AMENDMENT OF SOLICITATION/MODIFICATION OF CONTRACT			1. CONTRACT ID CODE N/A		PAGE OF PAGES 1 70
6 ICCLIED BY	3. EFFECTIVE DATE SEP. 03, 2004	4. REQUISITION/PURCHAS N/A		SPEC. 1	NO. (If applicable) NO. 1406
DEPARTMENT OF THE ARMY U.S. ARMY ENGINEER DISTRICT, SACR SACRAMENTO, CALIFORNIA 95814-2922	7. ADMINISTERED BY (If other than Item 6) DEPARTMENT OF THE ARMY U.S. ARMY ENGINEER DISTRICT, SACRAMENTO SACRAMENTO, CALIFORNIA 95814-2922

14. DESCRIPTION OF AMENDMENT/MODIFICATION (O. California Army National Guard (CAARNG) Readiness Center Lancaster, California	0 - 2	s, including solicitation/contrac	t subject matter where fe	asible.)	
2 Encl.					
 Revised Pages: List of Drawing and Specing 02230-1,02260-1,02300-1,02300-3,0274 09310-3,09511-4,09511-5,09680-1,09912 Revised Drawings: T000, C101, C102, C103 S302,S303,S306,S410,S412,S413,S414,S414 	1-8,02751-6,033000-4, 2-2,10200-3,10505-6,1 ,C110,A004,A005,A2	03470-3,05310-1,0811 5515-6,15839-2,15839 12,S100,S101,S110,S1	(0-3,08331-5,084) 9-3,15900-3,15900 111,S211,S220,S2	11-4,09260- 0-5	3,09310-2,
Except as provided herein, all terms and conditions of th and effect.	e document referenced in Ite	m 9A or 10A, as heretofore	changed, remain

T.O.C. @ 1ST EL. 100'-0"

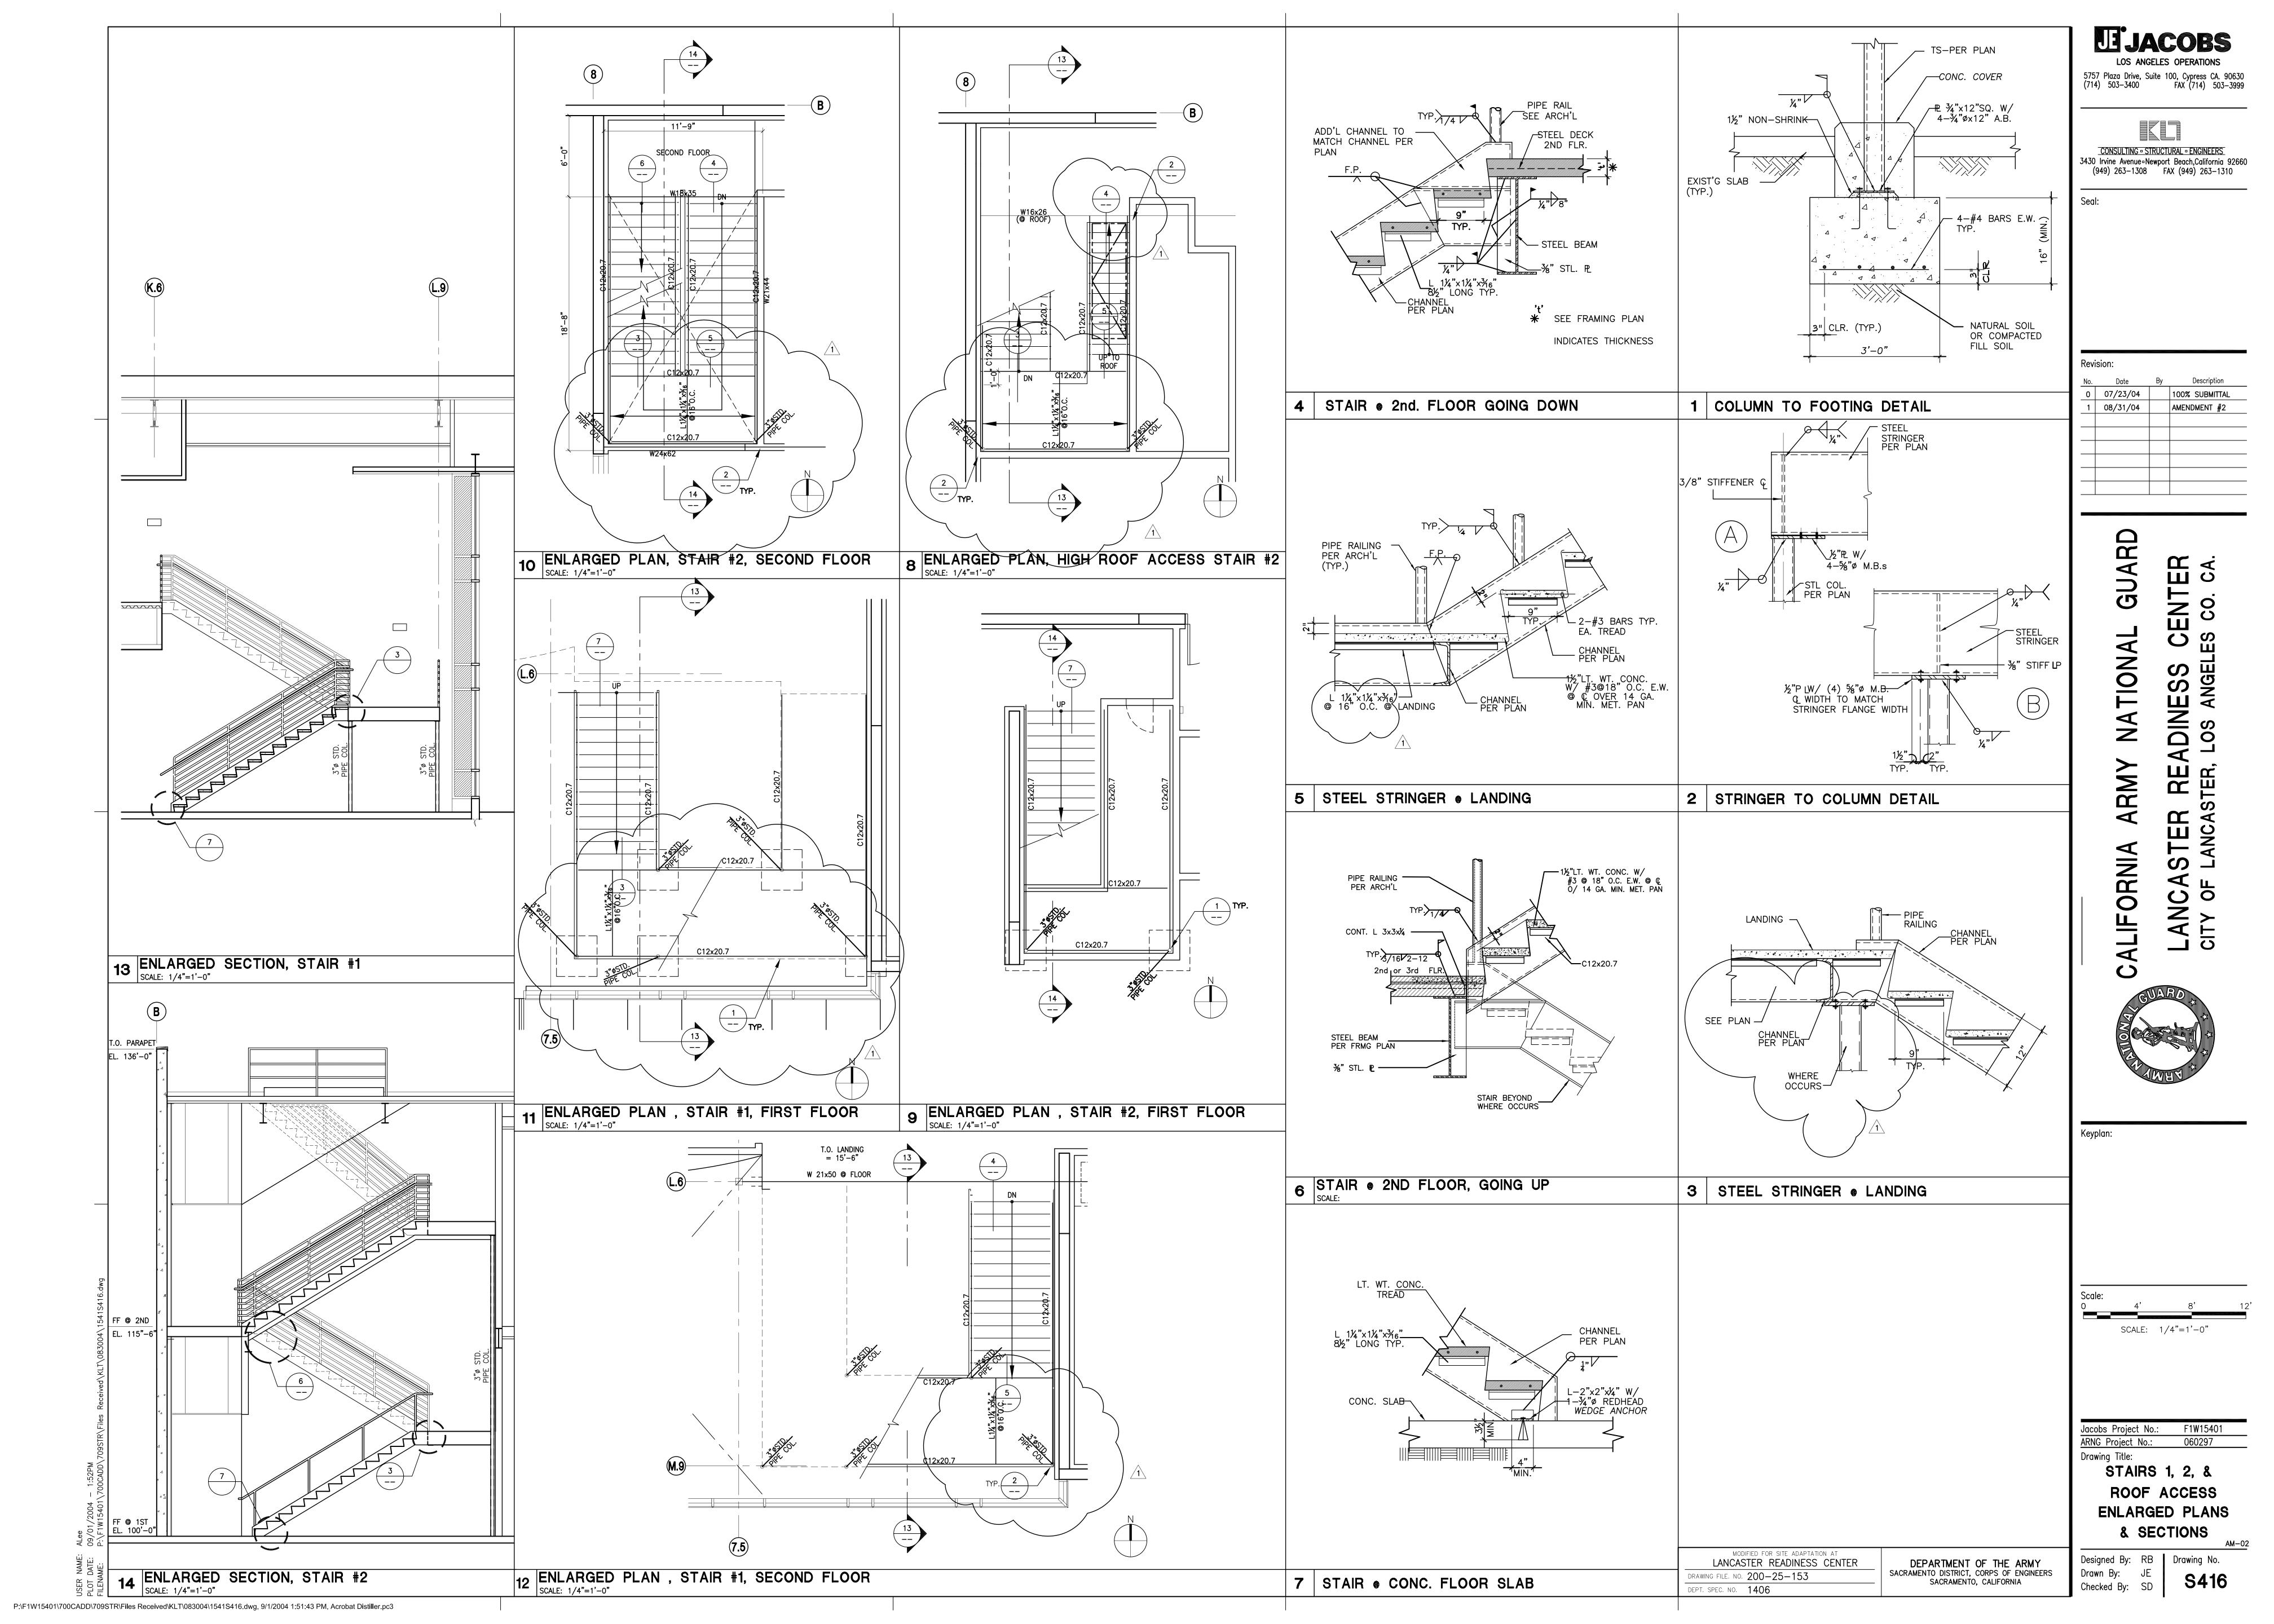
S302	Wall Panel Elevation	Revised a detail callout
S303	Wall Panel Elevation	Revised two detail callouts
S306	Wall Panel Elevation	Revised panel dimensions
S410	Structural Details	Added dimension on detail #3; Revised detail callouts in detail #16
S412	Structural Details	Detail #3 added weld symbol & revised note
S413	Structural Details	Detail #2 and 7 added note; Detail #9 and 13 deleted note; Detail #14 revised note; Detail #16 & 18 revised detail callout
S414	Structural Details	Detail #2 and 3 revised detail callout; Detail #7 added dimension; Detail #9 and 17 revised note; Detail #14 deleted note; Revised detail #19
S416	Stairs 1, 2, & Roof Access Enclosed Plans & Sections	Revised note in detail # 3 and 5, revised enlarged plan # 8, 9, 10, 11 and 12
03300	Cast-In-Place Concrete	Revised Part 2.2 (F.2)
03470	Tilt-up precast concrete	Revised Part 2.1 (B)
05310	Steel Deck	Add Part 1.2 (2)

ELECTRICAL OVERALL SINGLE LINE DIAGRAM

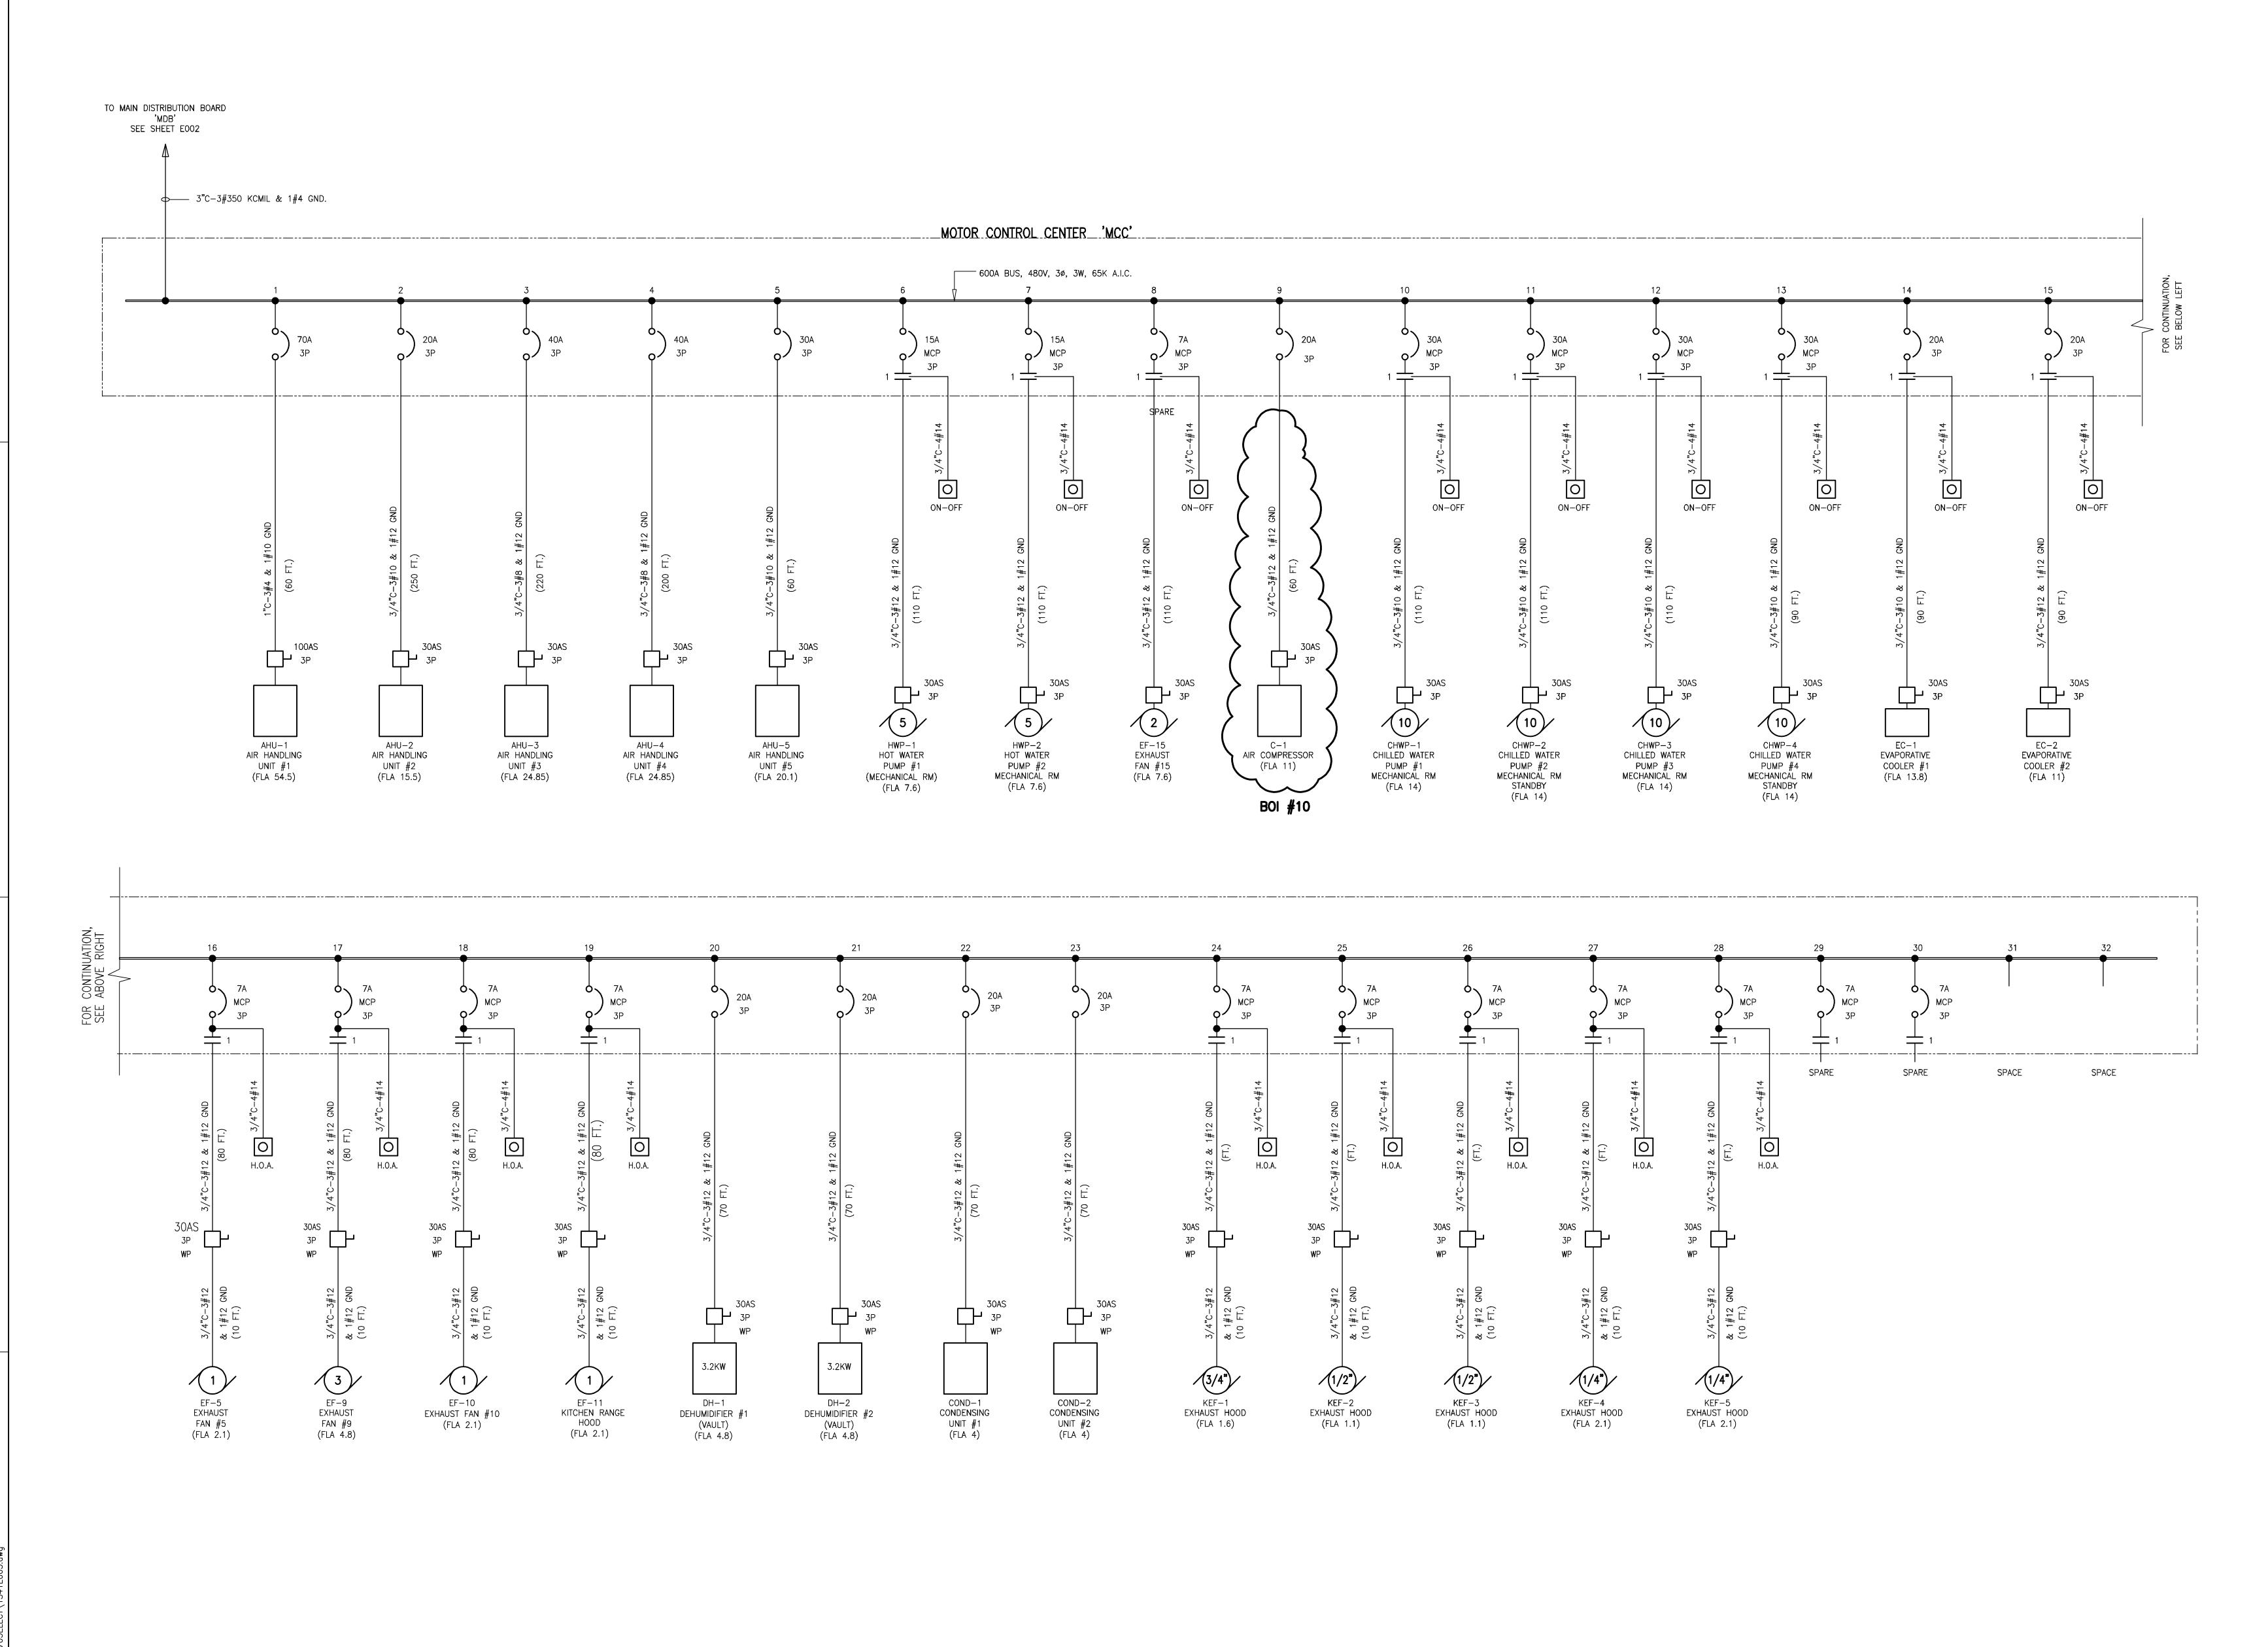
Sheet	Drawing Title	Summary of Changes
E002	Electrical Overall Single Line Diagram	Added keynote 3 & 4
E003	Electrical 480V MCC Single Line Diagram	Issued for construction
E100	Electrical Site Plan	Added fuel pump on site plan
E221	Electrical Second Floor Plan Sector 1 Lighting Plan	Revised keynote 1
E312	Electrical First Floor Sector 2 Power Plan	Revised detail callout
E530	Electrical Roof Fire Alarm Plan	Revised keynote 1
E801	Electrical Lighting Fixture Schedule	Revised lighting fixture schedule types T & AAA remarks Deleted type U
